ANN ARBOR HOUSING BOARD OF APPEALS

STAFF REPORT

Type of Request: APPEAL

Building Board of Appeals Request **BBA21-001** at 830 Henry, ANN ARBOR, MI 48104.

Existing Condition Photographs

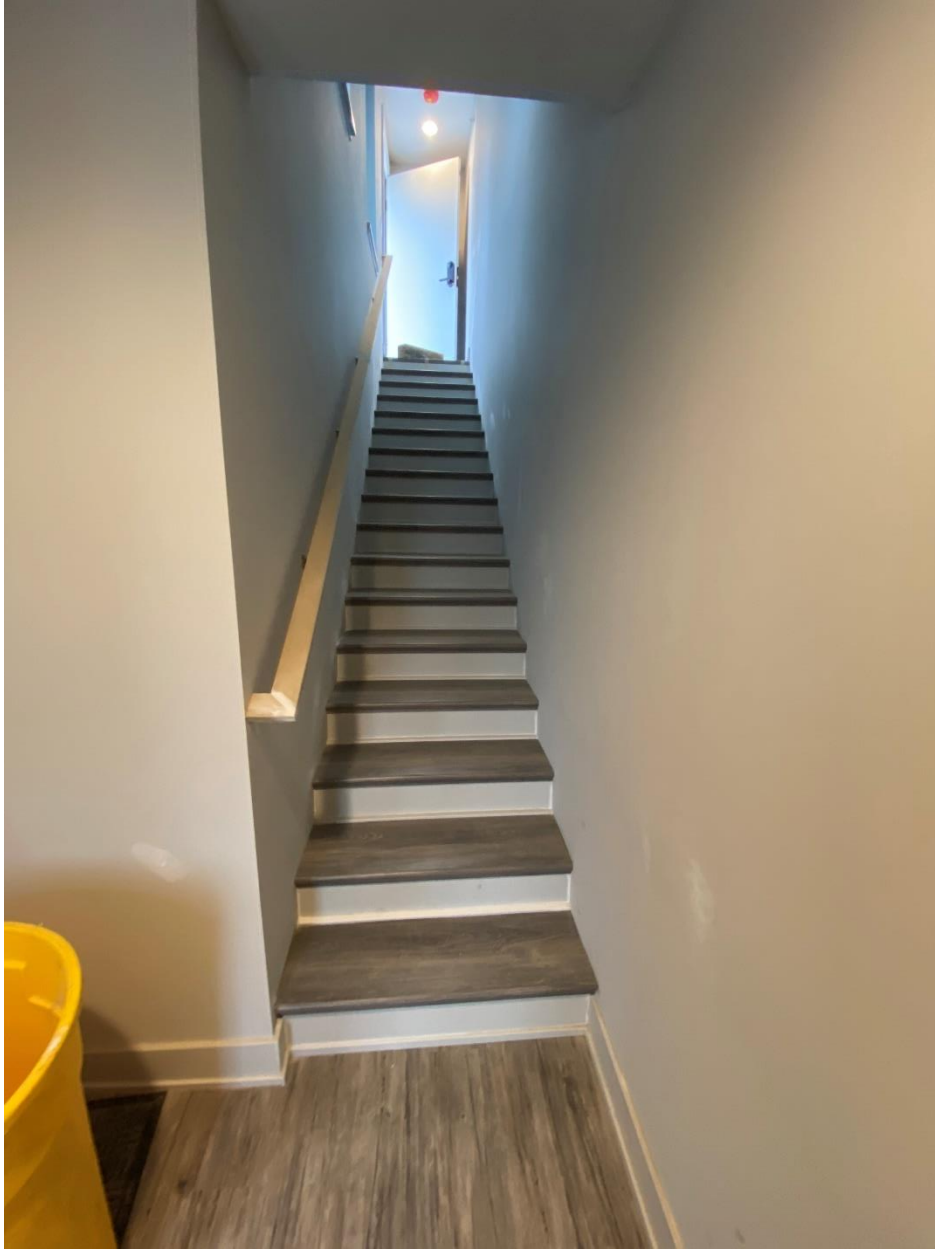
The stairs in question are fully constructed at this time. This by itself does not justify the nature of this request but is a fundamental hardship, admittedly self-induced, related to any outcome. In order to make the stairs compliant, 1" of additional width would need to be added to the stair section. This is virtually unattainable at this time without a complete modification to not only the conventional wood framed walls but more so the removal of additional sections of precast slab and concrete covering. This is presently over 12" in total thickness. Only the western side of this slab opening is even accessible for additional inches as the eastern side is supported by a W8x31 steel beam which sits at the edge of this opening. Additionally, the western wall of the stair between the main level and the upper terrace is a load bearing wall that supports the roof framing. We certainly acknowledge that making a modification of this nature is not clinically impossible, but we cannot begin to understand the complications implicit in attempting this level of invasive surgery particularly in relation to the concrete core section that would require the most extensive modification.

The stair is fully compliant in all other measures related to code requirements.

1. View of stair from main level to lower level

2. View of stair from lower level to main level

3. View of stair from main level to upper level (outdoor terrace)

4. View of stair from upper level (outdoor terrace) to main level
